THE CITY OF SPRUCE GROVE

BYLAW C-1066-19

East Pioneer Area Structure Plan Amendment

AREA STRUCTURE PLAN AMENDMENT

**STORM
SERVICING CONCEPT**

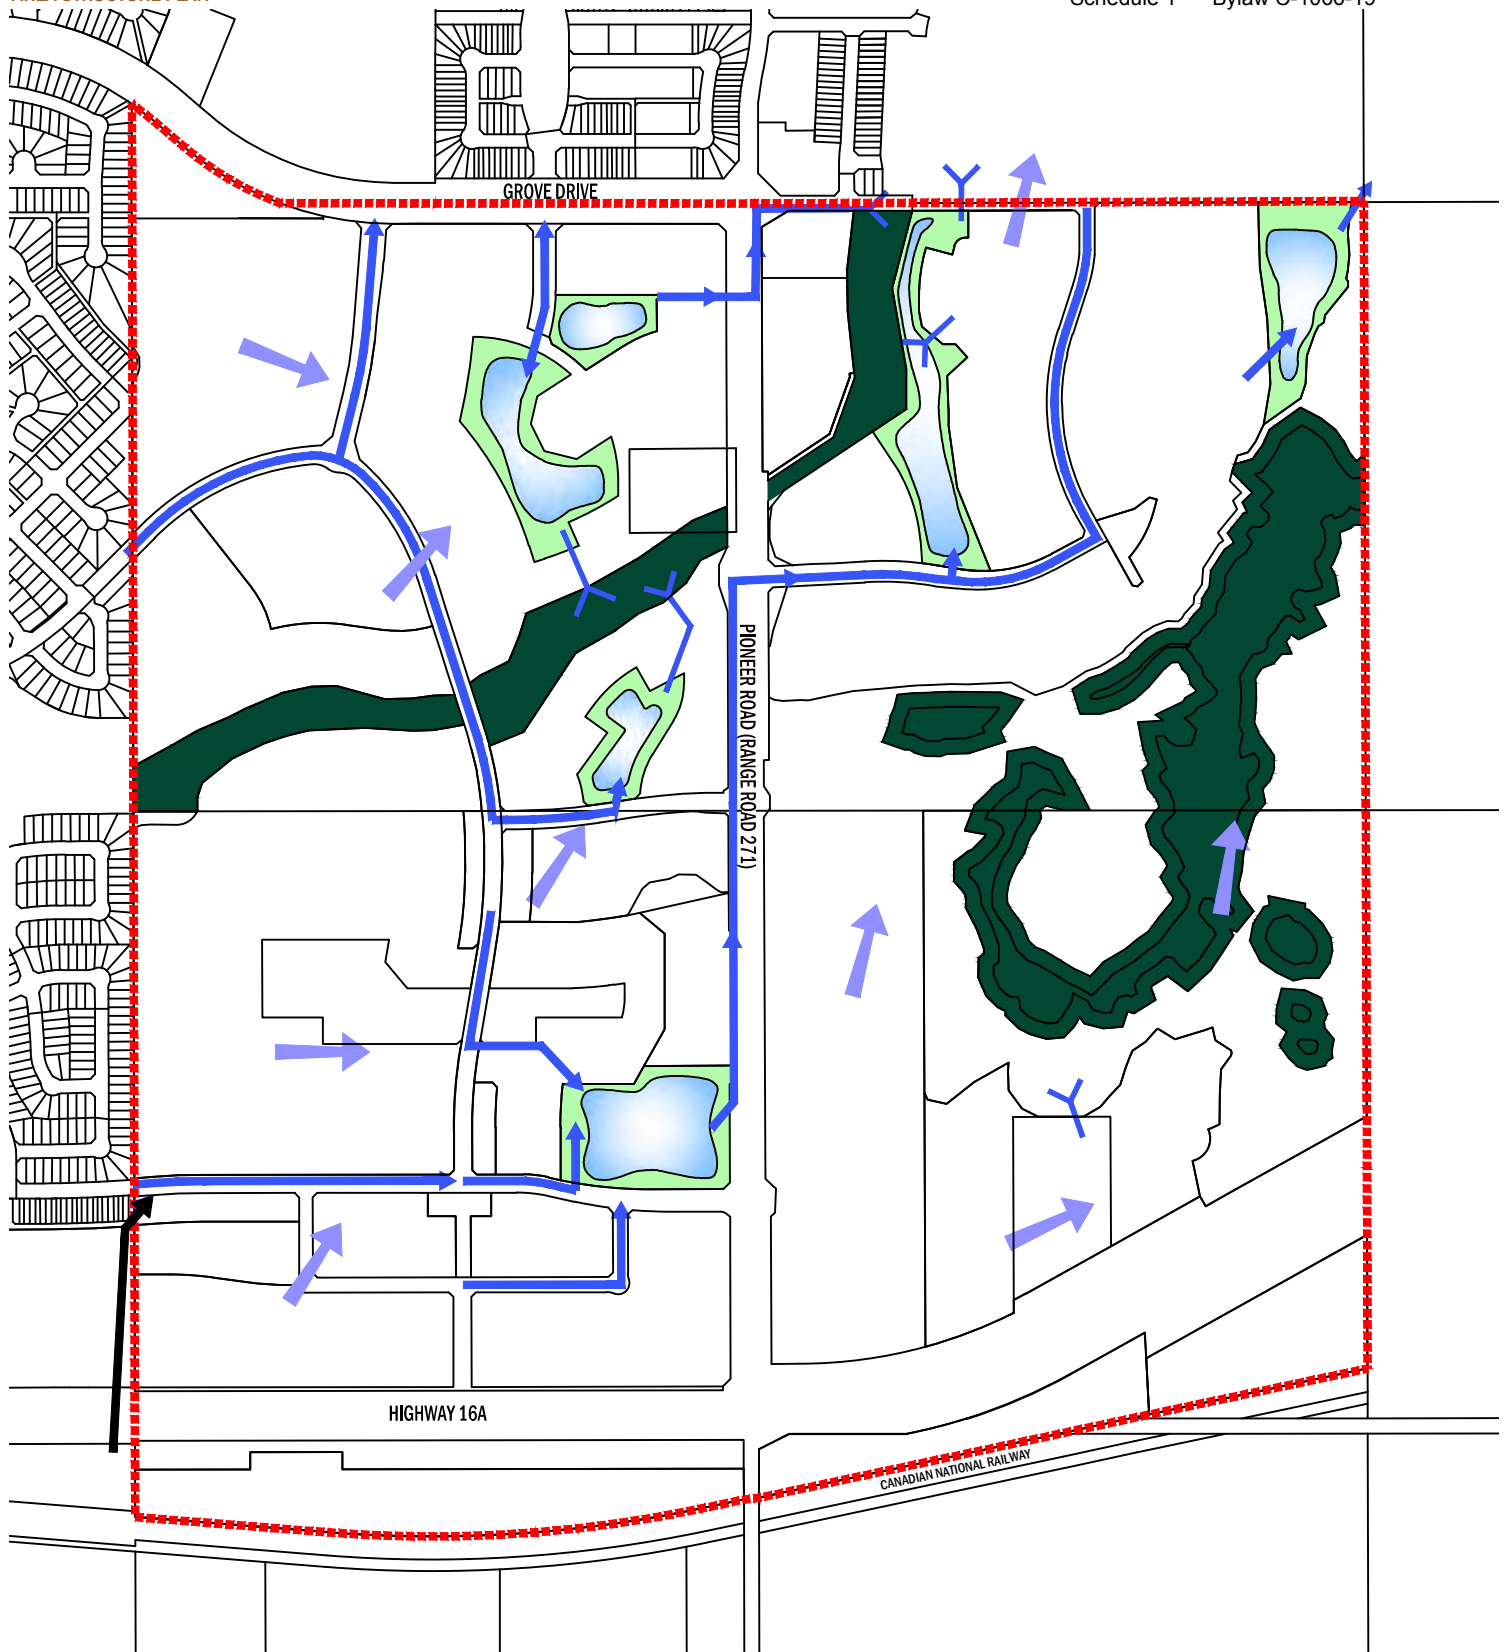
At the request of the City, the Storm Servicing Concept for the ASP has been updated to include flow from approximately 136 ha of predevelopment area. These lands are outside the ASP (to the south) and are currently flowing north through a culvert beneath Highway 16A and are, on the interim, flowing into the Lakewood stormwater system. The City has requested that this flow be accommodated within the Easton neighbourhood. This stormwater is to be transmitted to the Pioneer Road minor system; retention is not required nor provided. This change has been identified on Figure 8.

Figures 8, 9, and 10 have been updated to illustrate the servicing concept with the revised transportation network and the proposed location of the Easton stormwater management facility.
